1242, 1250, 1260, 1270 Gordon Street and 9 Valley Road, Guelph, ON – Environmental Impact Study Addendum

Report

August 30, 2021 File: 161413684

Project No.	Scale _{0 5}	15 25m
161413684	1:500	
Drawing No.	Sheet	Revision
GP-1	5 of 7	0

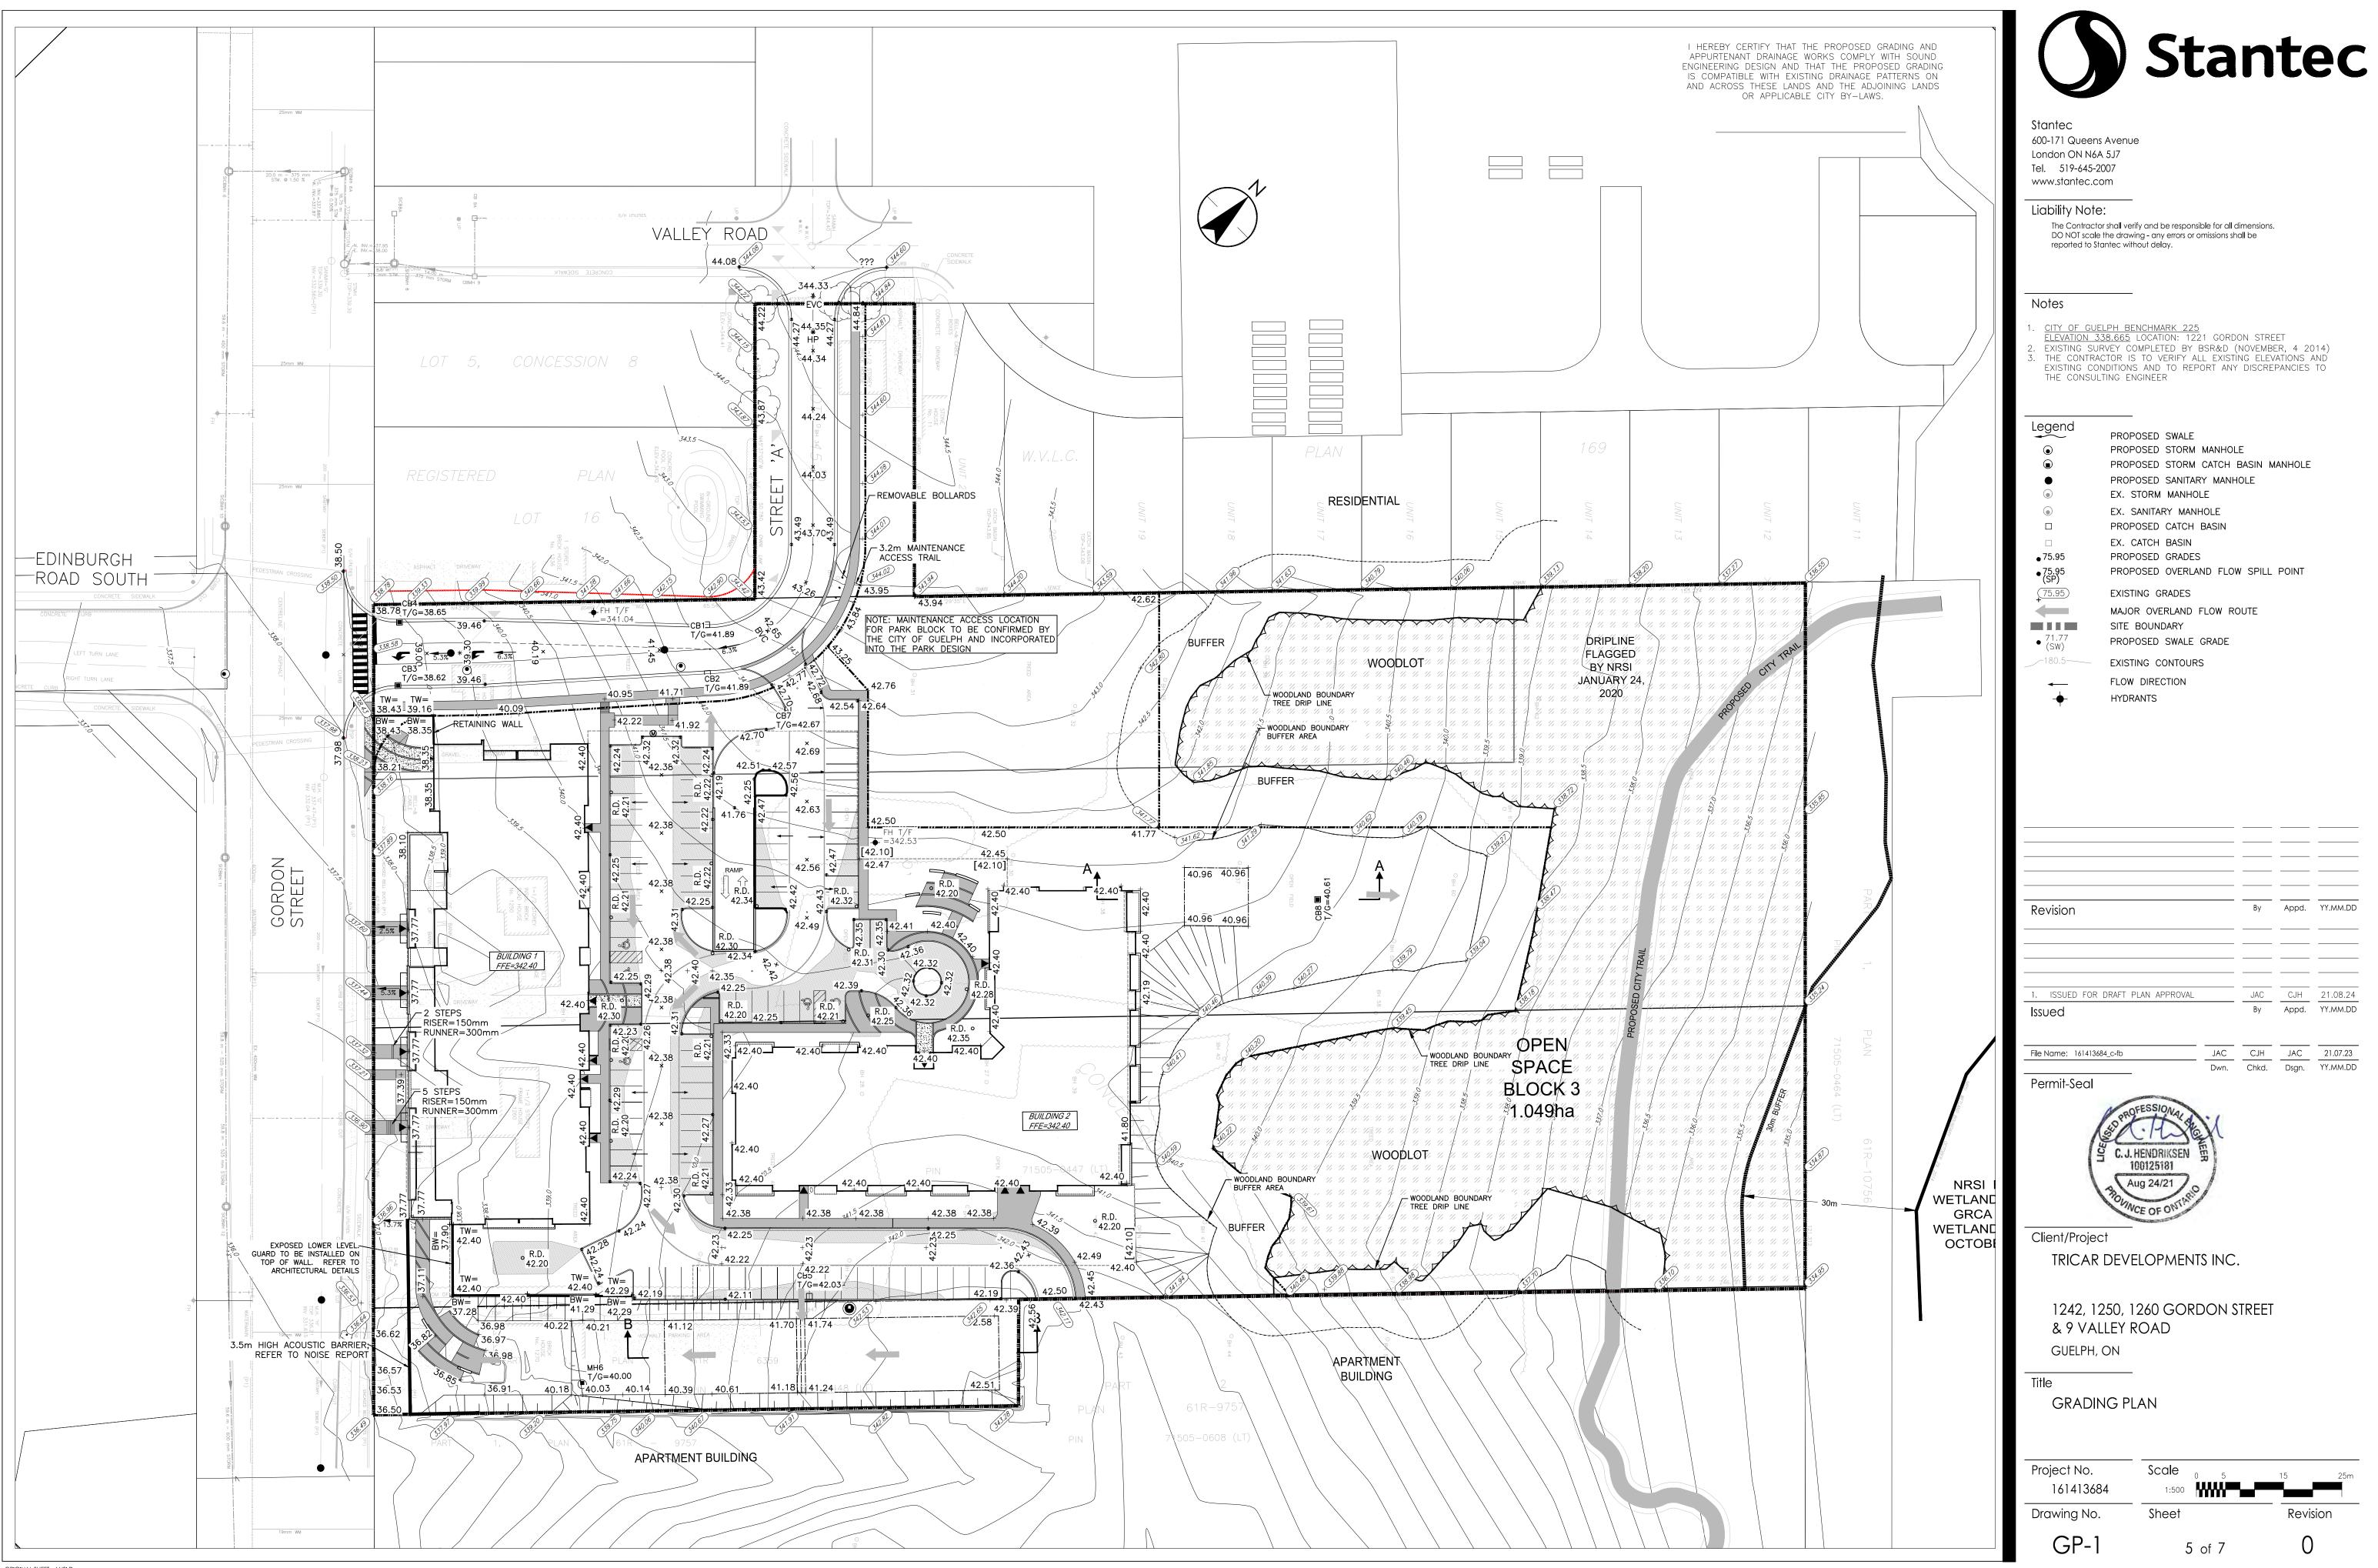
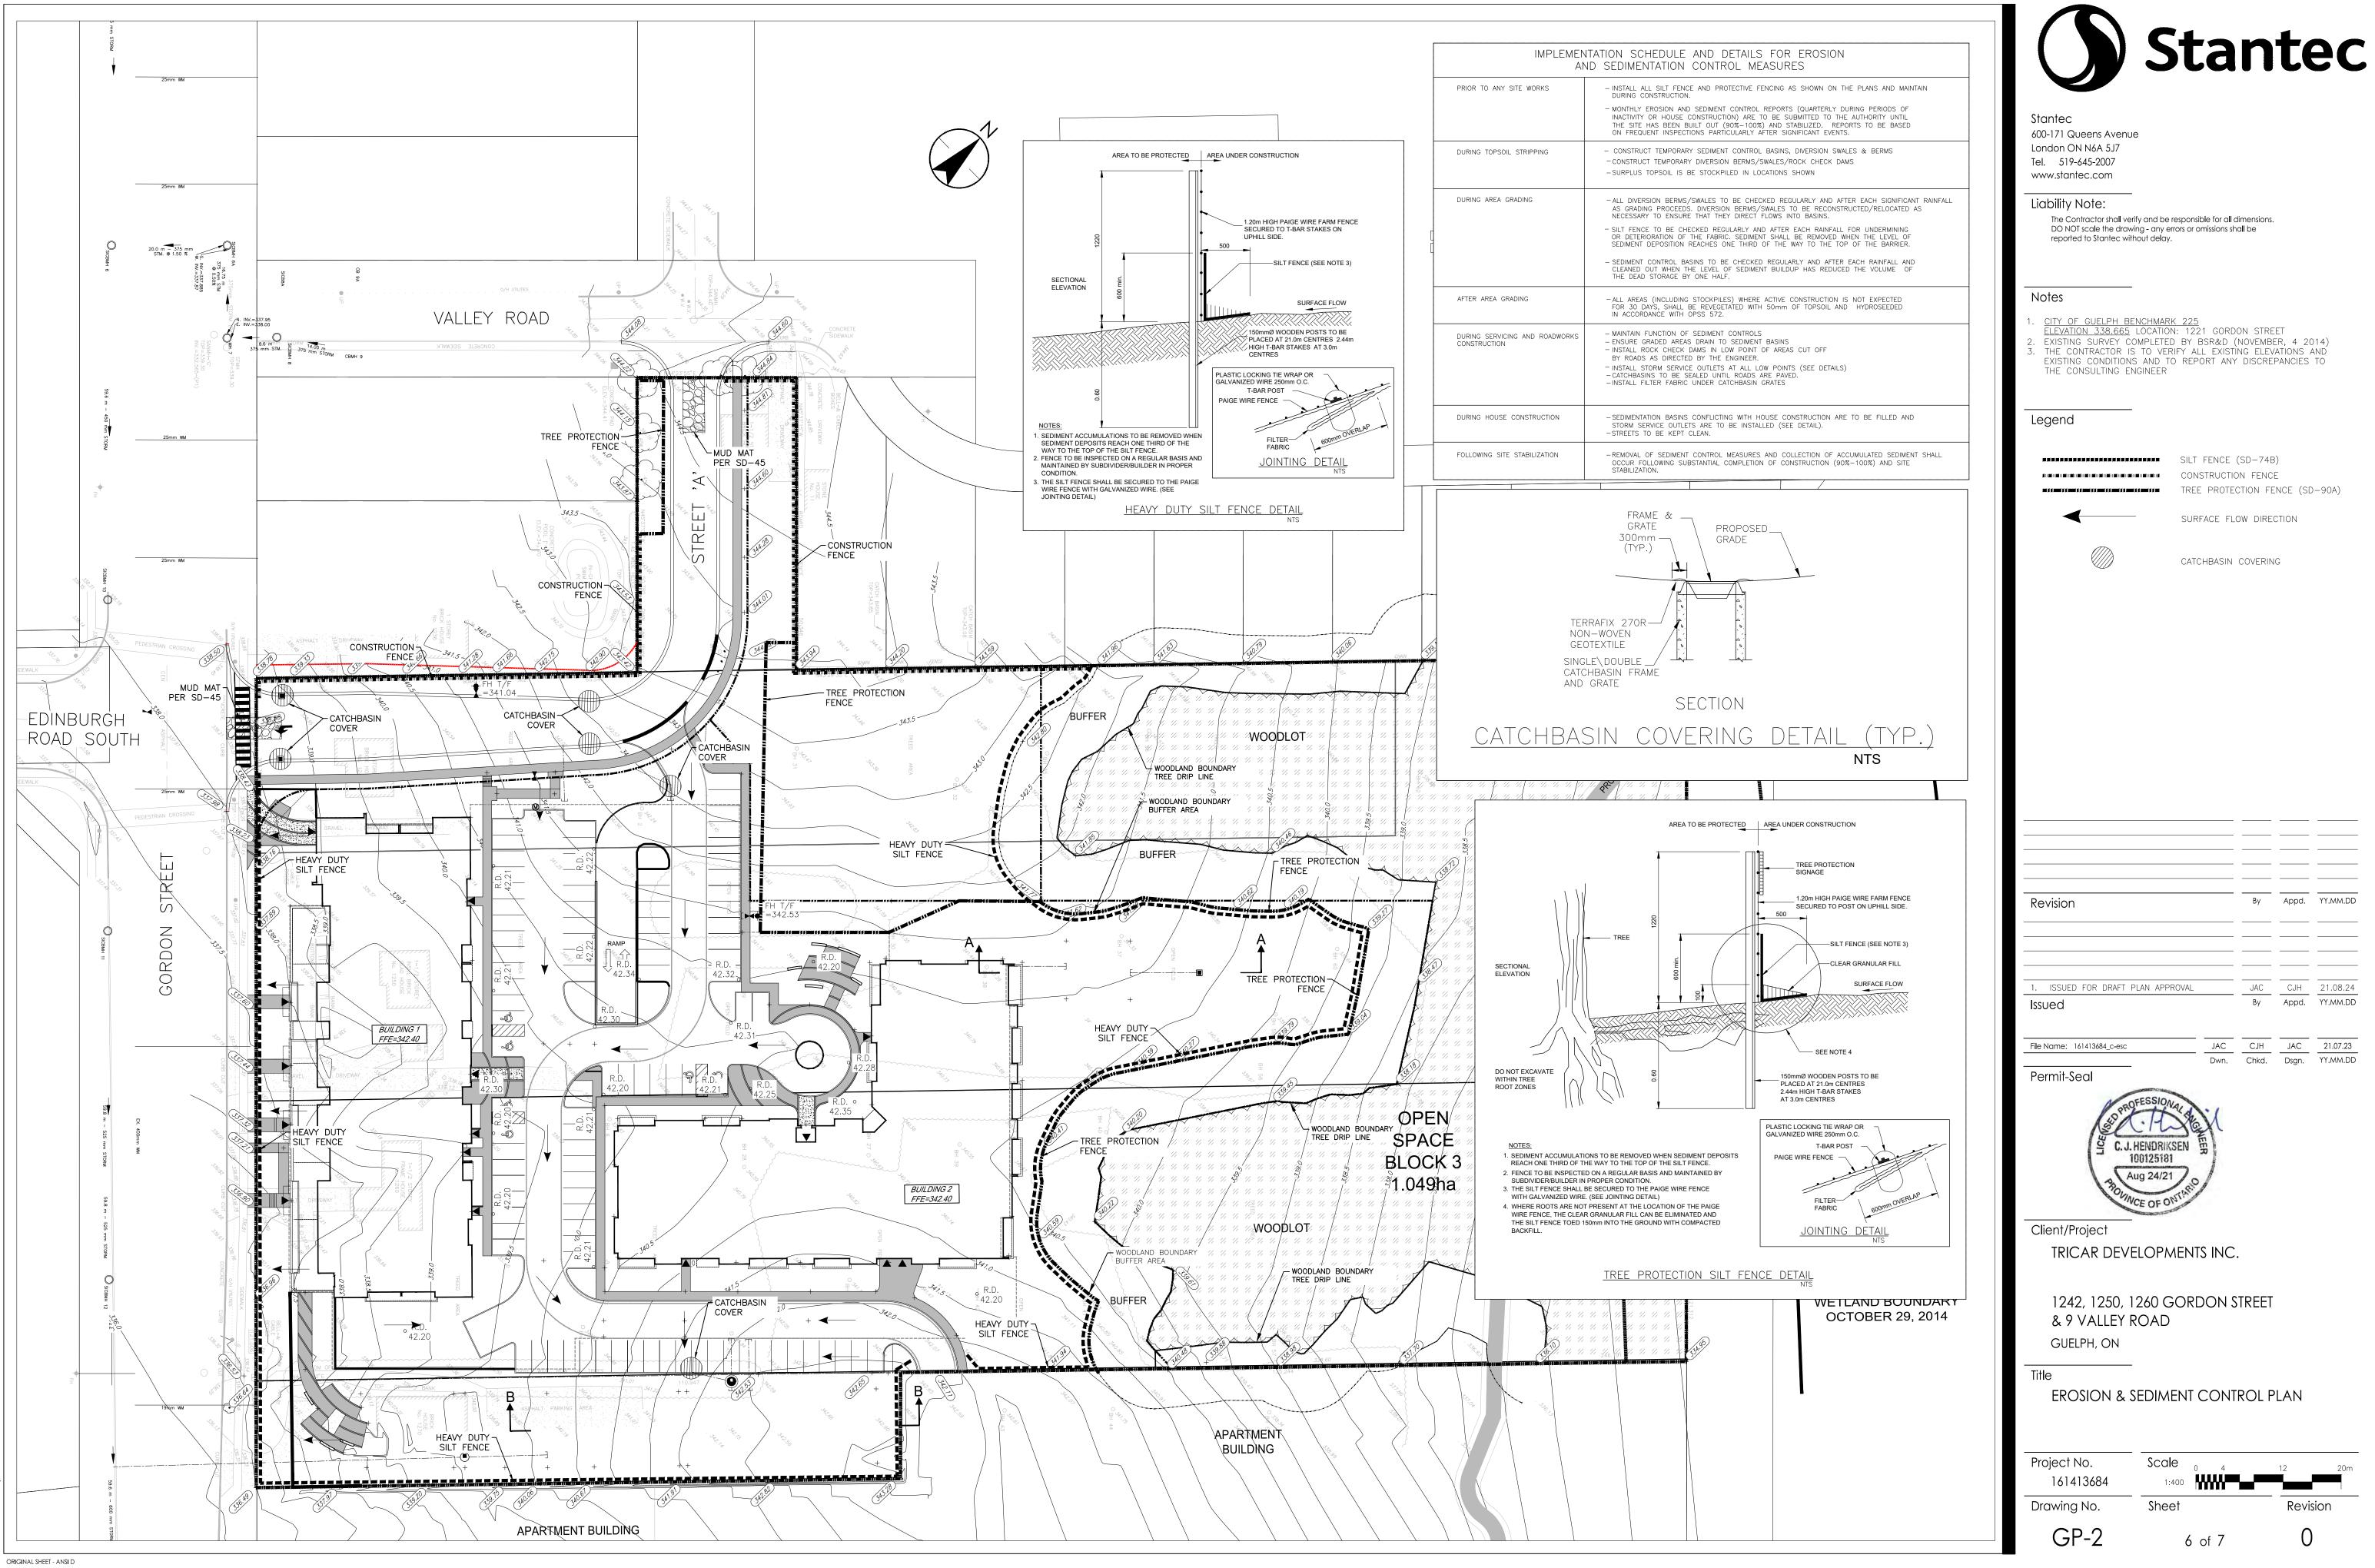
- 61. Drawing GP-1 Grading Plan indicates that extensive grading is required adjacent to the natural heritage system. Please provide additional detail on grading requirements (e.g. spot elevations) to enable a proper assessment of consistency with Official Plan policy. Please note that a cross-section can be helpful in demonstrating how the required grading relates to the protection of the natural heritage system. At a minimum, please update GP-1 to show differences in grade adjacent to the natural heritage system, and slope, particularly at the southeast end of the site.

172	60.Drawing SSP-2 Storm Drainage Area Plan – It is unclear how the Area IDs relate to the Catchments described in the FSR and Hydrological Investigation report's water balance calculations. Please ensure that this is clarified and coordinated among studies and drawings in the next submission.	Inconsistencies remedied in revised FSR.
173	61.Drawing GP-1 Grading Plan indicates that extensive grading is required adjacent to the natural heritage system. Please provide additional detail on grading requirements (e.g. spot elevations) to enable a proper assessment of consistency with Official Plan policy. Please note that a cross-section can be helpful in demonstrating how the required grading relates to the protection of the natural heritage system. At a minimum, please update GP-1 to show differences in grade adjacent to the natural heritage system, and slope, particularly at the southeast end of the site.	Grading is no longer proposed within established buffers.
